**BEFORE THE PUBLIC UTILITIES COMMISSION
OF THE STATE OF CALIFORNIA**

Rulemaking 12-11-005
(Filed November 8, 2012)

**COMMENTS OF POWERTREE SERVICES INC.
ON PROPOSED DECISION REGARDING NET ENERGY METERING
INTERCONNECTION ELIGIBILITY FOR STORAGE DEVICES PAIRED WITH
NET ENERGY METERING FACILITIES**

Load-Leveling Storage with Premise PV and Loads

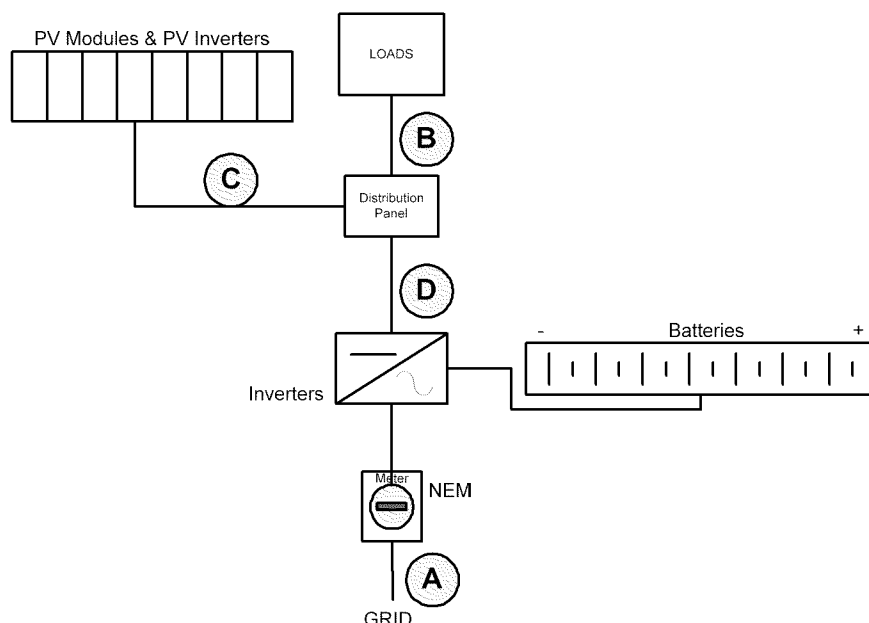
In this configuration the storage system (such as a stationary battery or vehicle-to-grid-equipped vehicle) is purposed to provide load leveling, peak management services, or demand response services. It is NOT configured for enhanced reliability/backup or operation as a generator on the CAISO system.

The power/energy appearing at the grid connection equals B minus C plus D (although D may be a positive or negative number).

As PV Generation power (C) is fixed, and NEM solar systems are generally sized such that peak load power (B) is greater than or equal to the peak solar generation, then ***to be most effective the storage power (D) needs to be able to be sized to as large as Load (B), NOT limited to the size of the PV Generation (C) as currently proposed.*** For behind-the-meter storage systems focusing on reducing shorter-duration peaks, 1-2 kWh per kW of usable energy should be sufficient.

AC Coupled Storage Added to Premise PV and Loads

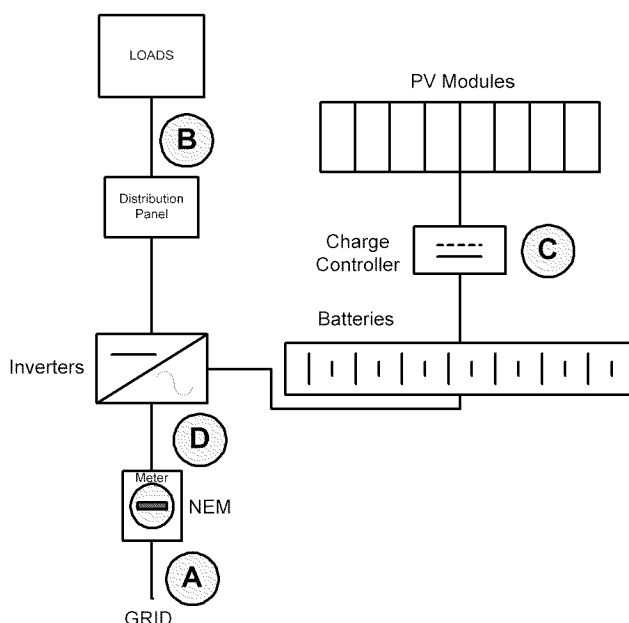
In this configuration the storage system is purposed to provide a variety of services including reliability enhancement/backup, load leveling, demand response, or peak management services. It is NOT configured to operate as a generator on the CAISO system due to jurisdictional conflicts and accounting issues surrounding the mixing of wholesale and retail energy purchases behind a NEM.

The power/energy appearing at the grid connection equals $B \text{ minus } C \text{ minus } D$ (although D may be a positive or negative number).

As PV Generation (C) is fixed and loads (B) are greater than or equal to the generation then ***to be most effective the storage power (D) needs to be able to be sized to as large as Load (B), NOT limited to the size of the PV Generation (C) as currently proposed.*** Hours of usable energy need to be higher here as the desired purposes of peak management, **load shaping and reliability require more hours of usable energy (4 to 20 kWh per kW).**

DC Coupled PV and Storage to Premise Loads

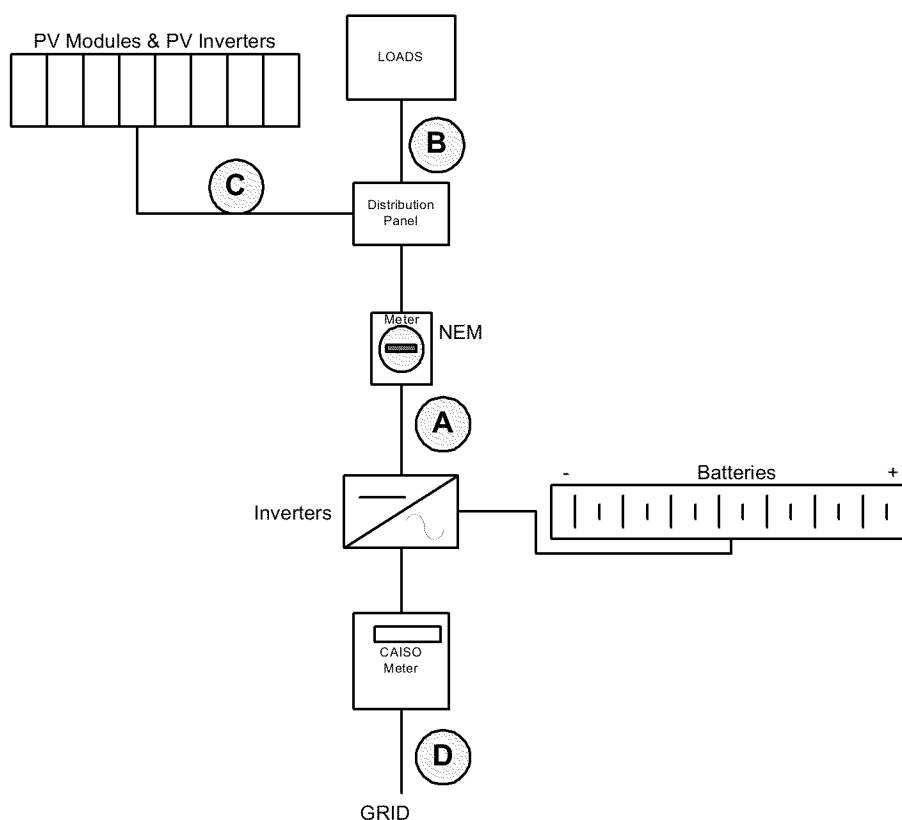
In this configuration the storage system is purposed to provide a variety of services including reliability enhancement/backup, load leveling, demand response, or peak management services. It is NOT configured for operation as a generator on the CAISO system due to jurisdictional conflicts and accounting issues surrounding the mixing of wholesale and retail energy purchases behind a NEM.

The power/energy appearing at the grid connection (A) equals B plus D (although D may be a positive or negative number).

As PV Generation (C) is fixed and loads (B) are greater than or equal to the generation then ***to be most effective the storage power (D) needs to be able to be sized to as large as Load (B), NOT limited to the size of the PV Generation (C) as currently proposed.*** Hours of usable energy need to be higher here as the desired purposes of peak management, **load shaping and reliability** require more hours of usable energy (4 to 20 kWh per kW).
